Moriah War Memorial College Association

Moriah War Memorial College Existing Conditions Road Safety Audit

August 2019

Figure 3-5 Baronga Avenue – Lighting

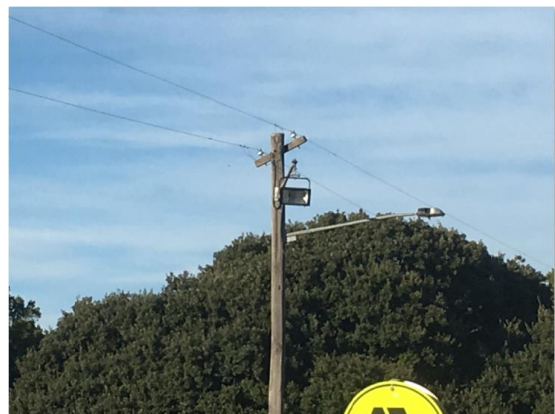
The site inspection was only carried out during the daylight period during the school peak AM and PM peak pick up and drop off times, therefore current operation of the lighting was not able to be observed. However, it was identified at the pedestrian zebra crossing on Baronga Avenue had lighting for crossing on angle that may create artificial glare to southbound vehicles on approach to the pedestrian zebra crossing (refer to Figure 3-5). Such glare may affect the visibility of opposing approaching vehicles or pedestrians on the pedestrian zebra crossing resulting in potential pedestrian/vehicles impact or head on crash of approaching vehicles.

Figure 3-12 Temporary traffic control devices

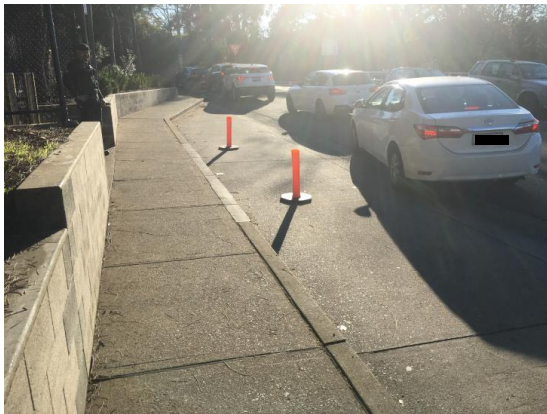
It was observed at the site inspection that temporary traffic control devices (i.e. cones and bollards) were utilised on the public road to manage temporary pick up and drop off operations or to prevent parking in areas (i.e. as in front of school gates). Some of the devices utilised were not in line with current standards for temporary traffic control devices. Such items include:

- Bollards that did not contain reflective bands and were cut shorter and now less than the minimum 750 mm height (refer to Figure 3-12).
- Cones without non reflective bands (refer to Figure 3-12).

Utilising temporary traffic control equipment not to the current standard may not be visible to drivers and therefore be impacted and become a hazard.

This was observed on one occasion on site at Gate 3A where a driver exiting from the lay-by did not see the bollard in front of the vehicle and run directly over it, moving it closer to the traffic lane.
